**NOTICE 2 TO BIDDERS**  
**QUESTIONS AND ANSWERS**

**RT57-2022: SUPPLY AND DELIVERY OF SEDAN, LIGHT AND HEAVY COMMERCIAL VEHICLES, BUSES, MOTORCYCLES, AGRICULTURAL TRACTORS, CONSTRUCTION PLANT AND EQUIPMENT TO THE STATE FOR A PERIOD OF 36 MONTHS**

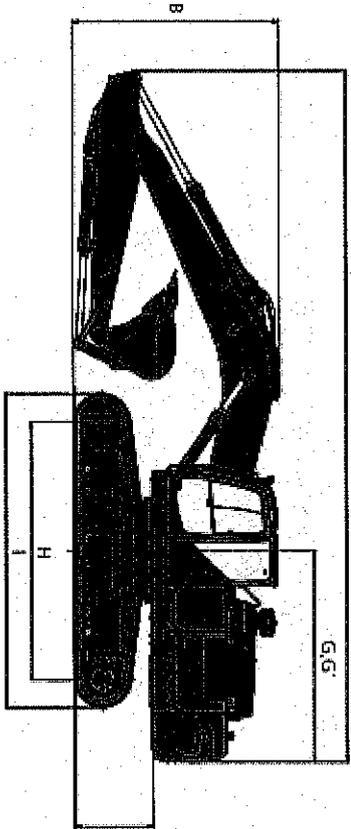
<p>operation and would like to recommend that the kW rating of the 12ton roller is lowered to 85kW Gross power.</p>	
<p><b>3. RT57-09-05-02</b>  <u>Crawler Mounted Hydraulic Excavator – 30 000kg</u></p> <ul style="list-style-type: none"> <li>The track length dimension of 'I' below has been specified as min 5000mm in the RT57. Checking the specification of the 2 brands that Bell distributes (JCB and Kobelco) and the dominant excavator competitors in South Africa, it is clear that the track lengths vary between 4800 and 4950mm. Bell recommends that this requirement is changed to minimum of 4800mm.</li> </ul> 	<ul style="list-style-type: none"> <li>This is a rounded of number and slightly more or less will be accepted.</li> </ul>
<p><b>19</b></p> <p><b>4. RT57-09-05-01/02/03</b>  <u>Crawler Mounted Hydraulic Excavator</u></p>	<ul style="list-style-type: none"> <li>Bidders must refer to document "13- Addendum A- RT57-09 - GENERAL SPECIFICATIONS, Clause 17 PAINTING"</li> </ul>
